**SUBMISSION TO FUTURE MELBOURNE (PLANNING) COMMITTEE MEETING 12 JULY 2022
AGENDA ITEM 6.3
Application for Planning Permit PA2101470
Ministerial Planning Referral TPM-2022-1
Lot B, 473-505 Docklands Drive, Docklands**

This letter is to address two of DELWP and CoM's comments on the West B development in Docklands.

Figure 4 – Area of louvred façade as highlighted in yellow – approx 670m² of 1470m², or 46% of total podium elevation.

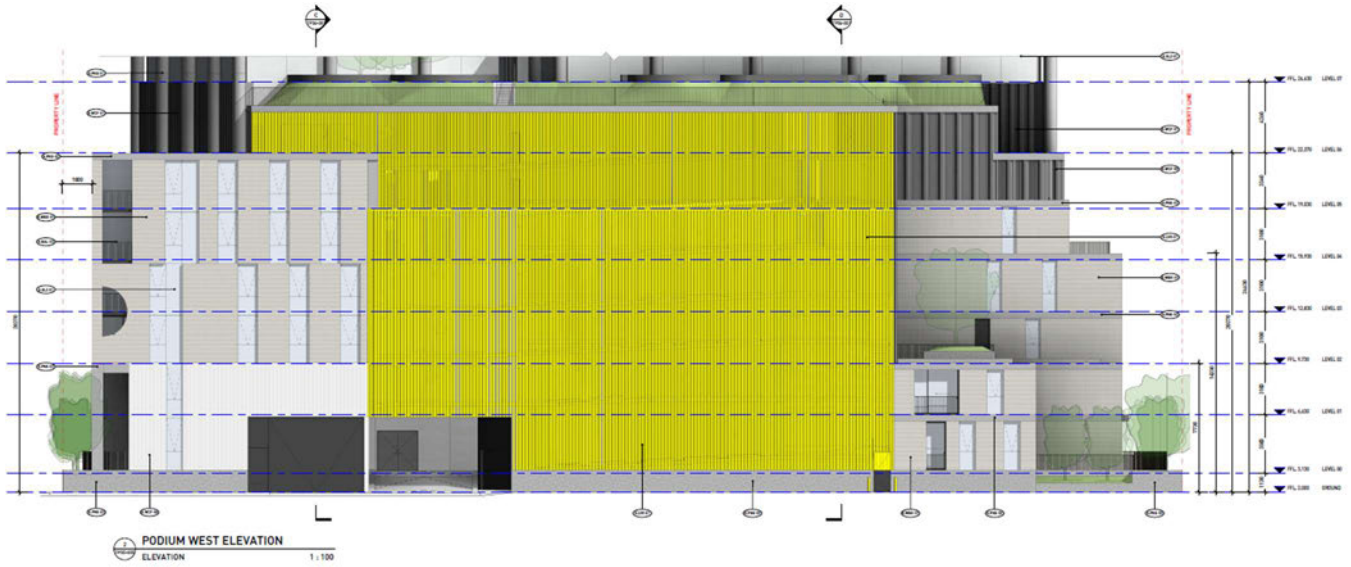
CoM's comment: 'We have concerns with the singular application of vertical louvres to the western podium carpark interface. The proposal emphasises the scale of this inactive interface, and will appear imposing and dominating over pedestrians. The standard application of a single material (louvres) over a vast podium car parking is no longer a design outcome that can be supported by the City of Melbourne.'

We recommend some further design rigour is pursued to this interface, to derive a design proposal which maintains permeability, but achieves some interest and breakdown in the height and bulk of the podium carpark interface to the street.

A potential option is expressing horizontal floor slabs, and incorporating a planter box to provide some further greening and visual interest.'

WM Response: The podium has been designed as a whole, taking interest from all sides of the façade. The western façade has a varied architectural language, with the apartments facing the Boardwalk and Linear Park wrapping around both the north-west and south-west corners.

The carpark entry is located along the western façade, and has been treated separately from the apartment materiality to create a varied articulation in the form and language of the building. At Level 5 and 6, the carpark interface is set back 5,025mm from the façade below, further breaking the mass of the podium height.

From an elevation point of view, the louvres are less than 50% of the finish (refer to Diagram 03, extent as highlighted in yellow), and approx. 30% of the louvred face is setback at levels 5 and 6 (refer to Diagram 04, extent as highlighted in orange).
